Technical Service Bulletin

42 Rear shock mounting noises

42 16 29 2042645/2 January 21, 2016. Supersedes Technical Service Bulletin Group 42 number 15-27 dated December 4, 2015 for reasons listed below.

Model(s)	Year	VIN Range	Vehicle-Specific Equipment
S3	2015	1116968 - 1999999 A127451 - A999999	Audi magnetic ride
S3	2016	All	Audi magnetic ride

Figure 1. Rear shock absorber assembly showing rear shock mount (point 4).

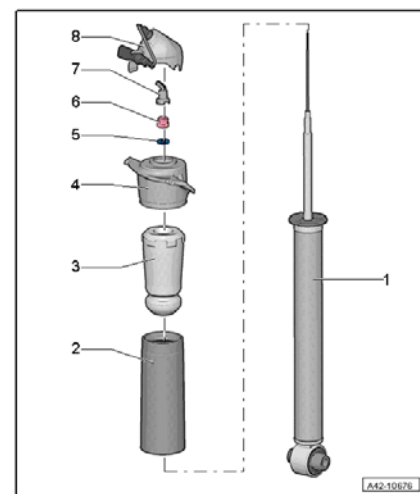
The rear shock mounts are causing the noises (Figure 1).

1. Verify that the noise is coming from the rear shock mounts.
2. Remove both rear shock assemblies and replace both rear shock mounts according to Elsa instructions.
3. Test drive to verify repair.
